DDEC® VI Troubleshooting

NUMBER: 07 DDEC VI-37 S.M. REF.: 86 ENGINE: EPA07 MBE 4000 DATE: December 2007

SUBJECT: SPN 1636/FMI 3

PUBLICATION: 6SE568

Figure 1 Intake Air Temperature Sensor

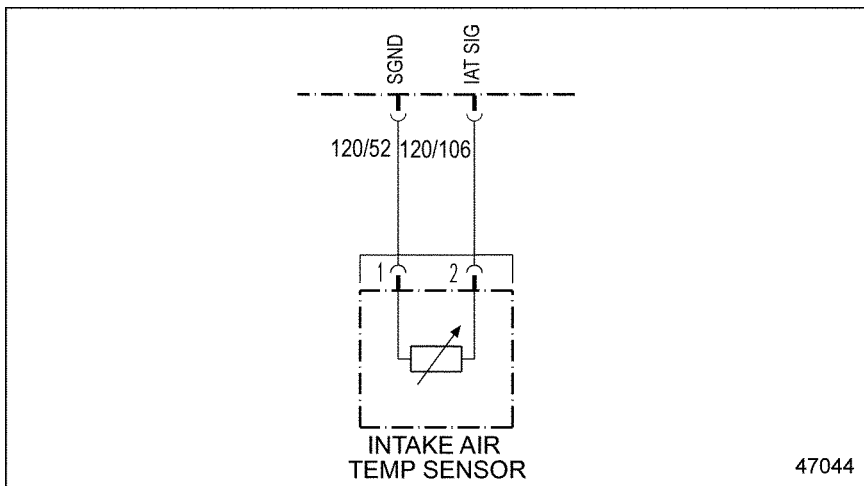
SPN 1636/FMI 3 has been changed.

1. Disconnect the Intake Air Temperature Sensor.
2. Turn the Ignition ON.
3. Measure the voltage between pins 1 and 2 of the Intake Air Temperature Sensor harness connector.
 - [a] If the voltage is greater than 2.75v, replace the Intake Air Temperature Sensor.
 - [b] If the voltage is less than 2.75v, go to step 4.
4. Measure the voltage between pin 2 of the Intake Air Temperature Sensor harness connector and ground.

- [a] If the voltage is greater than 2.75v, repair open between pin 1 of the Intake Air Temperature Sensor harness connector and pin 52 of the MCM 120-pin connector.
- [b] If the voltage is less than 2.75v, repair open between pin 2 of the Intake Air Temperature Sensor harness connector and pin 106 of the MCM 120-pin connector.
